Access Compliance Report

Public Rights-of-Way

(Curb Ramps)

Intersection ID: 13663	Main Street: KENHILL_DR	Cross Street: WEDGEFIELD_DR	Location: NW
ADA ID: 24165B3EB333	Ramp Type: PerpDiag	Initial Pass/Fail: Fail	Overall Compliance: No
		Severity Score: 8.75

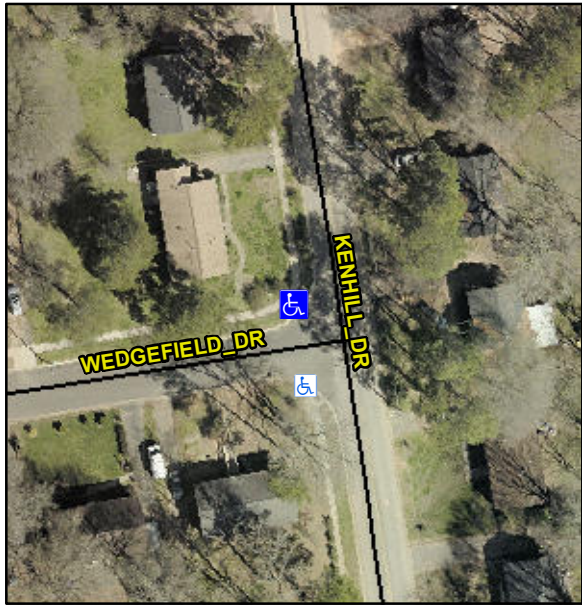
Codes/Mitigation Info/Possible Solution			Field Measurements/Component Compliance					
	Possible Solutions:		Compliance	Description	Data	Compliance	Description	Data
	Remove & Replace Curb Ramp With Two New Directional Ramps or Equivalent.		N/A	Ramp Length (in)	71.0	Yes	Ramp Slope (%)	5.9
			No	Ramp Width (in)	41.0	Yes	Ramp XSlope (%)	0.7
			N/A	Flare Type LT	N/A	N/A	Flare Type RT	N/A
			N/A	Flare Slope LT (%)	N/A	N/A	Flare Slope RT (%)	N/A
			N/A	Flare Traversable LT?	N/A	N/A	Flare Traversable RT?	N/A
			N/A	Landing Length (in)	N/A	N/A	DWS Provided?	N/A
			N/A	Landing Width (in)	N/A	N/A	DWS Contrast?	N/A
			N/A	Landing Slope (%)	N/A	N/A	DWS Length (in)	N/A
			N/A	Landing X Slope (%)	N/A	N/A	DWS Full Width?	N/A
Surveyor Notes:	N/A		N/A	Landing Curb? (Y/N)	N/A	N/A	DWS Offset (in)	N/A
			N/A	Shared Landing?	N/A			
			N/A	Gutter Ponding?	N/A	N/A	Gutter Slope (%)	N/A
			N/A	Gutter Lip Ht (in)	N/A	N/A	Gutter X Slope (%)	N/A

N/A	Painted X Walk1?	No	N/A	Painted X Walk2?	No
				X Walk 1 Direction	To S		X Walk 2 Direction	To E
			N/A	X Walk 1 Width (in)	N/A	N/A	X Walk 2 Width (in)	N/A
				X Walk 1 Slope (%)	0.2		X Walk 2 Slope (%)	5.2
				X Walk 1 X Slope (%)	3.2		X Walk 2 X Slope (%)	0.2
			N/A	Ramp inside XWalk1?	N/A	N/A	Ramp inside XWalk2?	N/A
PROW/ADA:	Not Found, R304.5.1			Road Slope (%)	3.6	N/A	Clear Space?	N/A
				Road X Slope (%)	4.3	N/A	Clear Space to XWalk (in)	N/A
			N/A	Any Obstructions?	N/A	N/A	Storm Grate/Utility Hazard?	N/A
				Obstruction Type			Storm Grate/Utility Type	
					N/A			N/A
						Yes	Surface Condition? (G/P)	Good
Total Cost:		\$	3200.00
